JP-4 SERVICE NOTES

Second Edition

INFORMATION ON DESIGN CHANGES

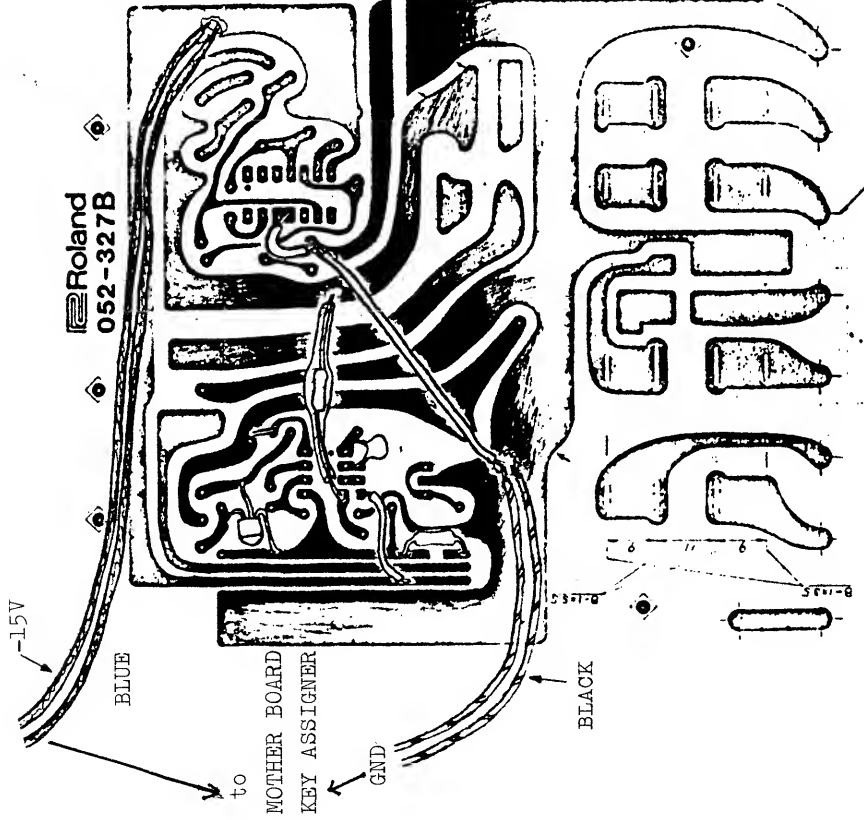
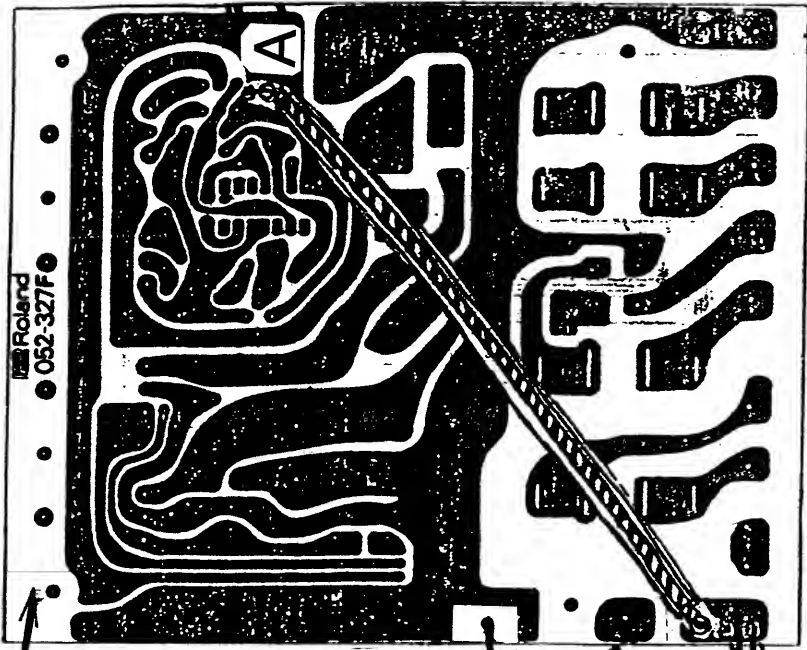
One of the important modifications for stable VCO pitch. Prevents voltage fluctuations on -15V and KCV circuits resulting from connectors' loose contacts. This has been done at the factory with serial number 871600 and subsequent, and will prove effective when done on the products left undone.

Before soldering, locate the -15V and ground points, and check them for the voltages since the jumper wires on the foil side and terminals are different from pcb to pcb, even in a version. Assume the drawings on this page as a reference, not a practical instruction.
